Expert Witness Report - Heritage

Johnston Street, Collingwood and Abbotsford

Yarra Planning Scheme Amendment C220

Proposed Design and Development Overlay DPO15

Figure 1 – Upper Level Setback Requirement Building Envelope Requirement

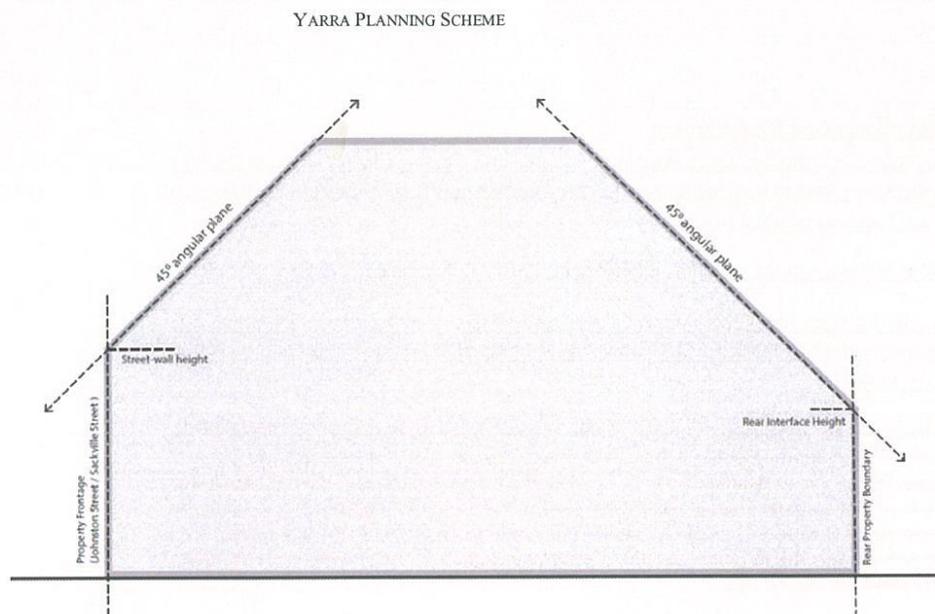
New development on sites with a north-south orientation fronting either Johnston Street or Sackville Street, should be setback from the front and rear property boundary, as illustrated in Figure 1 and as specified in Table 1.

The front and rear setback/envelope requirements are also illustrated in Figure 1.

In complying with the 45-degree envelope requirement, development should provide incremental setbacks of at least two storeys to avoid repetitive stepped form and 'wedding cake' outcomes.

In addition to the setbacks required by Table 1, new development on sites with a north-south orientation fronting either Johnston or Sackville Street, should be setback within a 45-degree envelope measured from above the street wall height and the rear interface height to the maximum overall height as shown in Figure 1. This does not apply to development in Precincts 1A, 1B, 2A and 2C (for the site on the northern side of Johnston Street), where new development should be setback within a 45-degree envelope from the primary street frontage only.
